Annex J Rawcliffe and Clifton Without Ward

J1 Location: Angram Close

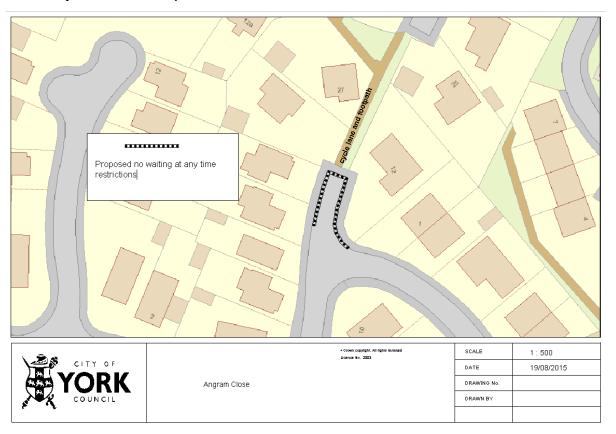
One resident has registered an objection

The zone covers the area outside my and elderly neighbours homes and would prohibit deliveries. I do not object to a no parking zone but banning waiting is inappropriate. One of my neighbours has dementia and cannot drive, he is in his 80s and frail therefore his essential shopping needs to be delivered but a delivery van would be unable to park outside his home to deliver to him.

All vehicles can park on yellow lines for the purpose of loading/unloading unless there is a loading ban in place. There is no loading ban proposed at this location.

All adjacent properties have an offstreet parking amenity.

The objector was informed the proposal would not prevent deliveries, however their objection was not withdrawn.
